H/Z-100 Field Service Bulletins

-- The following article appeared as an insert to issue #42, November-December 1995, of the "Z-100 LifeLine".

Z-100 Field Service Bulletins

- Z207 Schematic

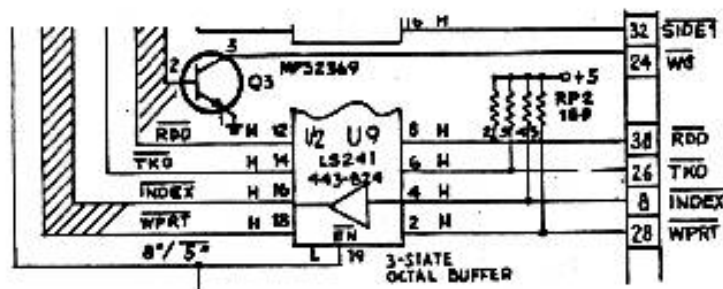
Locate the lower portion of U9 (near the 5" interface connector) and change the buffer symbol as follows:

FSB-Z100-024: Z-207 Floppy Disk Controller Card Soft Error Reduction

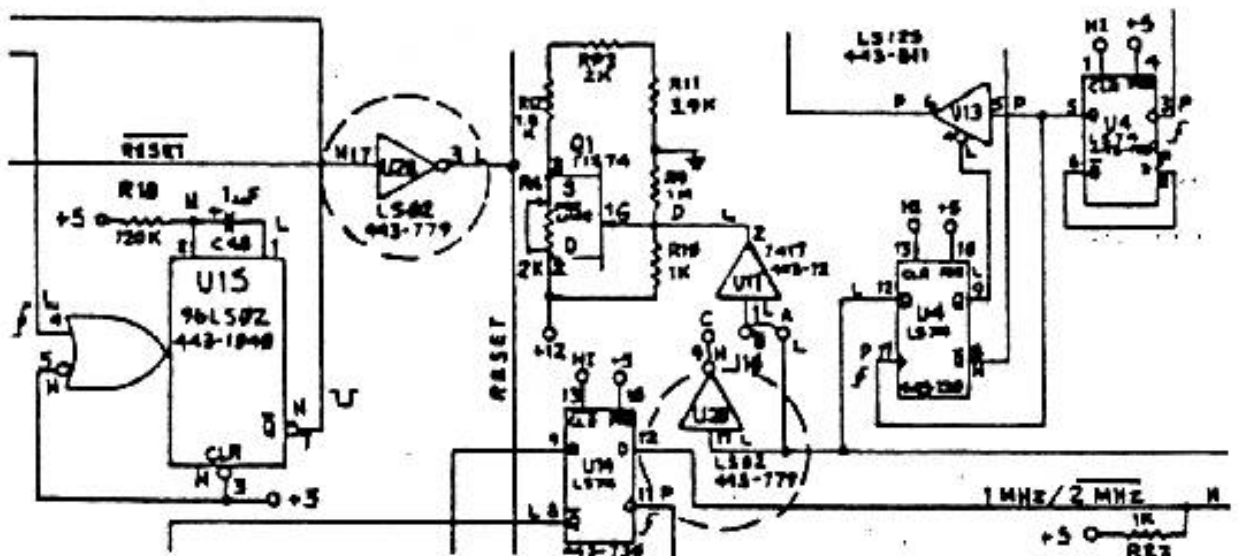
Connect a 10 uF capacitor in parallel with the 0.1 uF capacitor at C32. Be sure the

positive and negative leads of the 10 uF capacitor are positioned to the left of the component side of the board (with the 100-pin connector down).

This update was performed only "as needed." (*I don't know about earlier boards, but the 85-2807-2 and -3 boards already have both capacitors installed, as C32 and C32-1. Check earlier boards, the -1 board also may have it installed - ed.*)

FSB-Z100-036: Z-205 User Manual Corrections

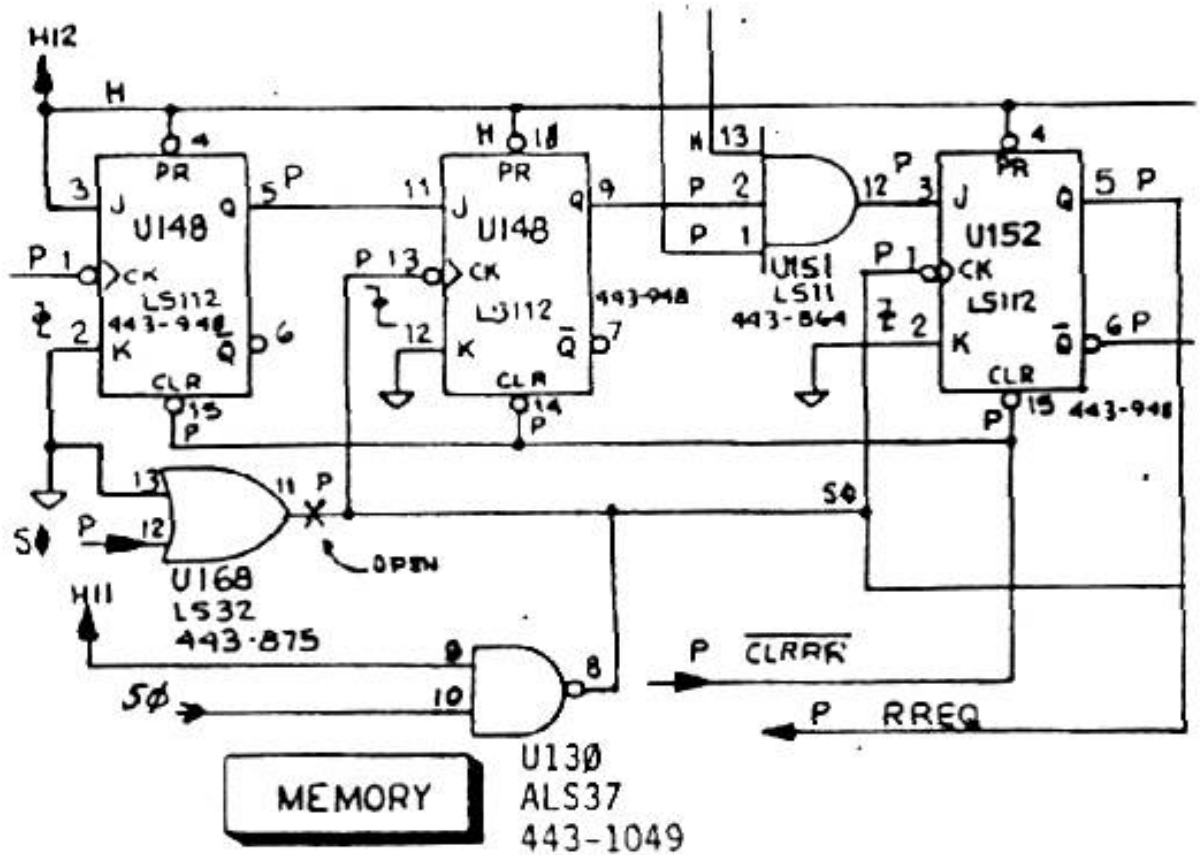
- Page 8: The 4th and 5th steps describing SW1 and SW2 are incorrect. See the following information for correct settings.
- Page 9: On Inset #1 there is a jumper displayed on J3. This jumper is not supposed to be there.
- The pictorial for SW1 (switch on right side) is shown with the wrong switch settings.

- Page 16: Under "Final Configuration, Multi-card", correct the first statement to read as follows:

-- Set dip switch SW1 positions 7, 4, 3, and 0 to the OFF (1) (LEFT) position. Set all the others to the ON (0) (RIGHT) position.

-- Set dip switch SW2 positions 2, 1, and 0 to the OFF (1) (LEFT) position. Set all the others to the ON (0) (RIGHT) position.

This will allow a user to operate two or more Z-205 memory cards (256K) in a contiguous mode, allowing the full 768K memory addressing ability of the Z-100 series computers to be implemented.
